Re: As-Built Baseline Report and Drawings for Hornpipe Branch Tributaries Site
(#100076)

RE: WLS Responses to NCDEQ DMS Review Comments for Task 6 Submittal, Final Baseline Monitoring Report for the Hornpipe Branch Tributaries Mitigation Project, DMS Full-Delivery Project ID #100076, Contract #7605, Neuse River Basin, Cataloging Unit 03020202, Lenoir County, NC

MYO FINAL MONITORING REPORT
Hornpipe Branch Tributaries Mitigation Project
Lenoir County
Neuse River Basin
CU 03020202

- Conservation Easement
- Reference Reaches
- Stream Restoration

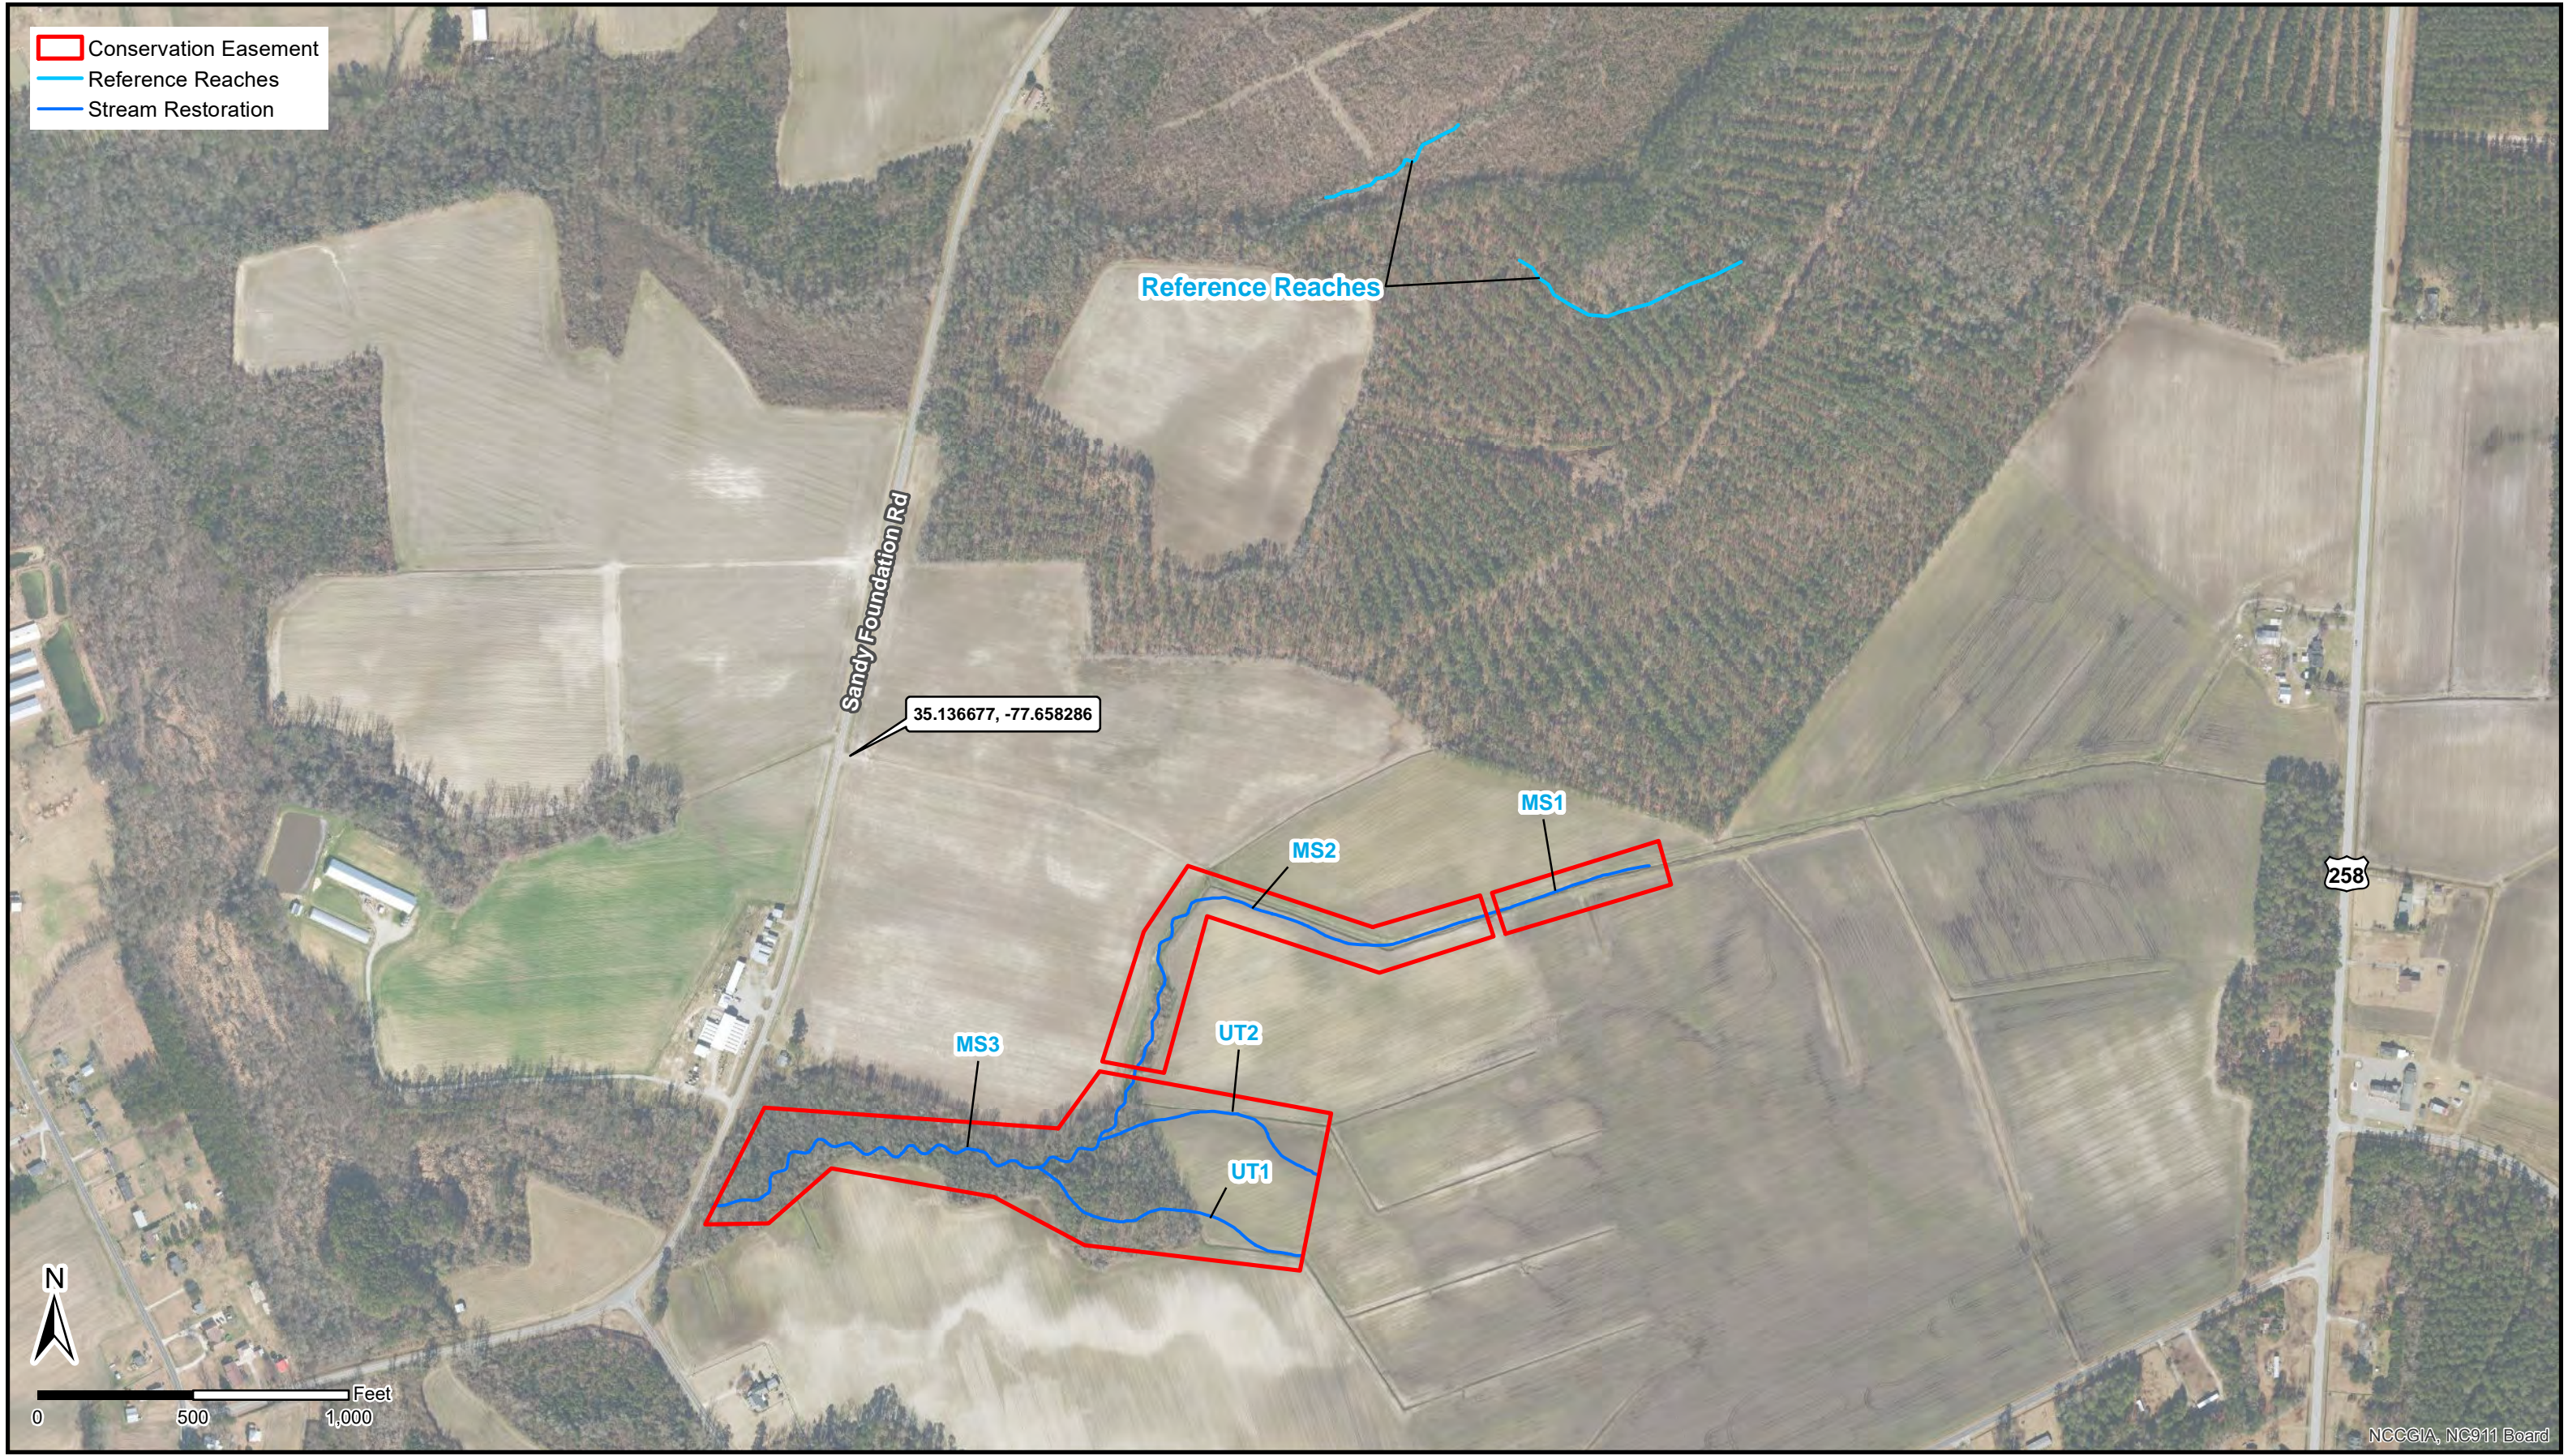
- **It appears that the flow gages on UT1 and UT2 were moved upstream as shown on the CCPV map and that the gauge is above the stated stationing for credit on UT2 (previously 10+62). This is a good installation choice given the DWR expressed concern during plan stages. Please clarify.** Response: Flow gauges on UT1 and UT2 were moved upstream due to lack of appropriate pools for accurate gauge readings. Language was also added to section 4.5.1 in the report document.

- **Consider showing where headwater stream credit starts for UT1 and UT2 on your CCPV.** Response: The stream sections on UT1 and UT2 that are non-creditable have been segmented and are now added to the legend and attribute table, per comment below.
